#### **CITY PLAN COMMISSION**

FILE NUMBER: M234-032(TZ) DATE FILED: July 10, 2024

**REQUEST:** An application for a minor amendment to an existing site plan,

STAFF RECOMMENDATION: Approval.

#### **PROPOSED SITE PLAN**

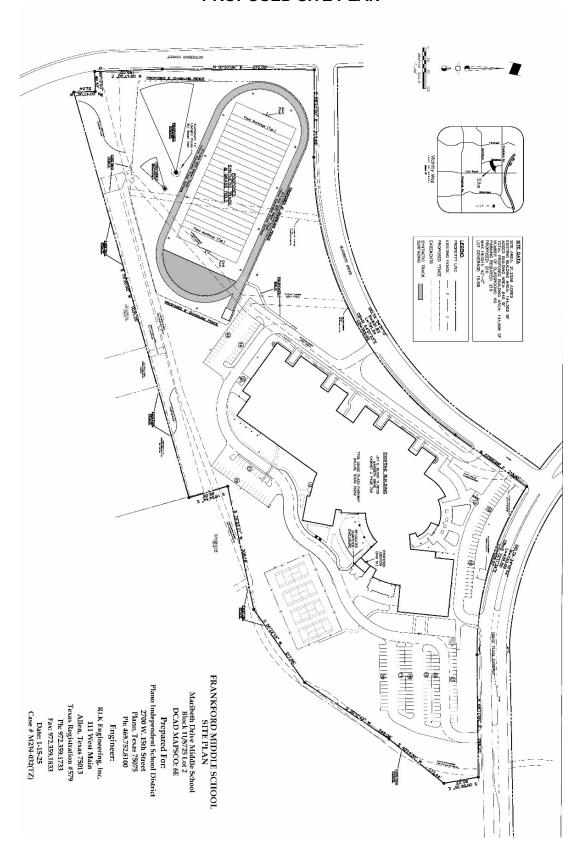
- 1. Modify the building footprint to add an approximately 620 square foot addition for a walk-in freezer;
- 2. Add an all-weather track and practice field on the western portion of the site;
- 3. Enclose the new track and practice field with a six-foot chain link fence;
- 4. Shift the dumpster location to allow space for the walk-in freezer addition;
- 5. Remove trees to accommodate the new track and practice field, replacing these with smaller plantings to retain the residential buffer;
- 6. Replace trees that are no longer in a healthy growing condition;
- 7. Amend the text of the traffic management plan (no changes are proposed to Exhibit 1 of the TMP).

Upon review of the proposed site plan, landscape plan, and traffic management plan, staff has determined that the request meets the minor amendment criteria for an SUP site plan and landscape plan, complies with the requirements set forth by Specific Use Permit No. 1305, and does not impact any other provisions of the ordinance.

#### PROPOSED LANDSCAPE PLAN

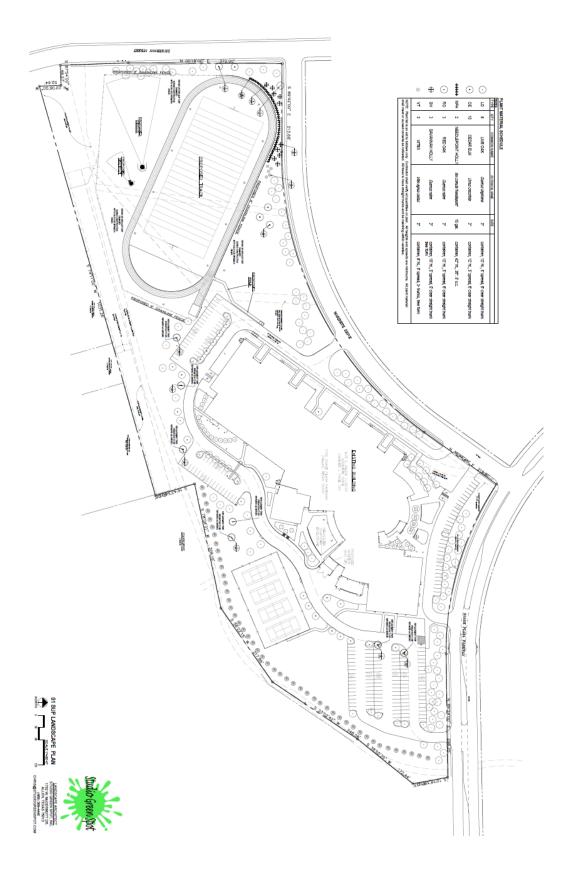
The city arborist has reviewed the request and has no objection to the proposed landscape plan.
